R44

SERVICE BULLETIN SB-51

SUBJECT: NAS6605-31 Bolts

SUSPECT NAS6605-31 BOLTS

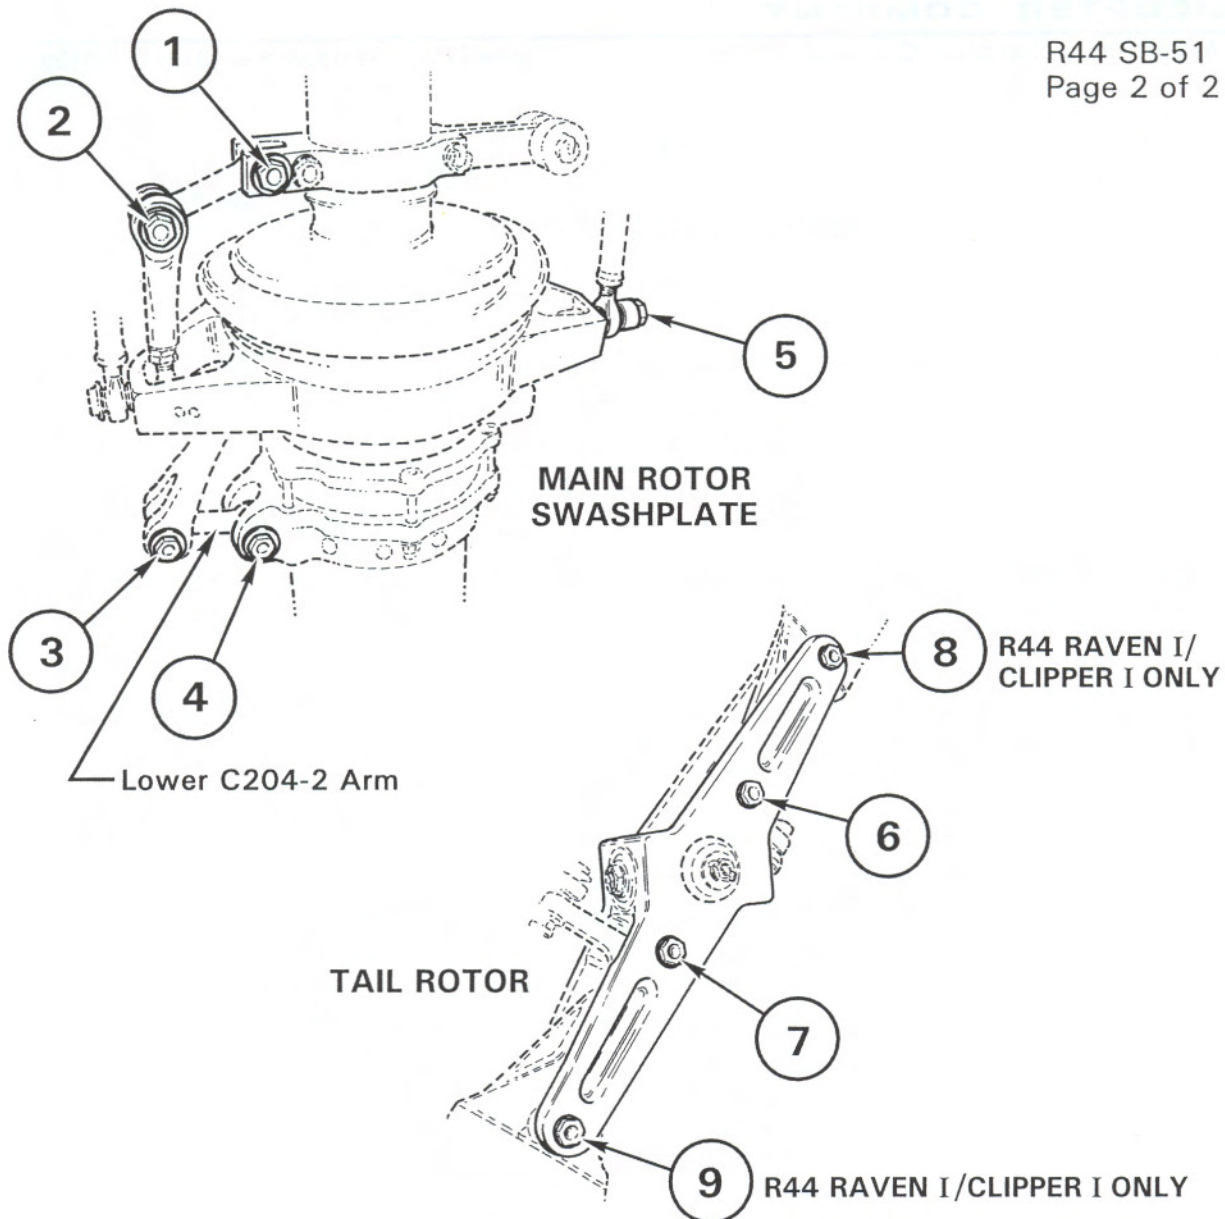
BACKGROUND: RHC has received one report of a failed NAS6605-31 bolt and has determined that the failure was due to hydrogen embrittlement. NAS6605-31 bolts are used 9 places on the R44 and 7 places on the R44 II as shown on the following page. Hydrogen embrittlement may occur due to improper process control during the cadmium plating process, making an entire manufacturing lot of bolts suspect.

Visually inspect all suspect NAS6605-31 bolts and verify no fretting residue under bolt head (residue would indicate a loose, potentially cracked bolt). Also apply approximately 10-15 ft-lb (13-20 N·m) torque to each bolt head and verify no rotation. It is not necessary to use a torque wrench; pilot or mechanic judgement using an ordinary wrench is adequate. Vary cyclic and collective position to provide access to bolts at lower C204-2 arm.

9 places on R44
7 places on R44 II

Order replacement NAS6605-31 bolts from RHC and replace all suspect bolts. Torque all fasteners per R44 Maintenance Manual. Destroy or return to RHC all removed bolts. Note that all suspect bolts will have vendor identification marking 01DO opposite the NAS6605-31 part number on the bolt head, but not all NAS6605-31 bolts with this marking are suspect. Replacement bolts will have an alternate vendor identification marking.
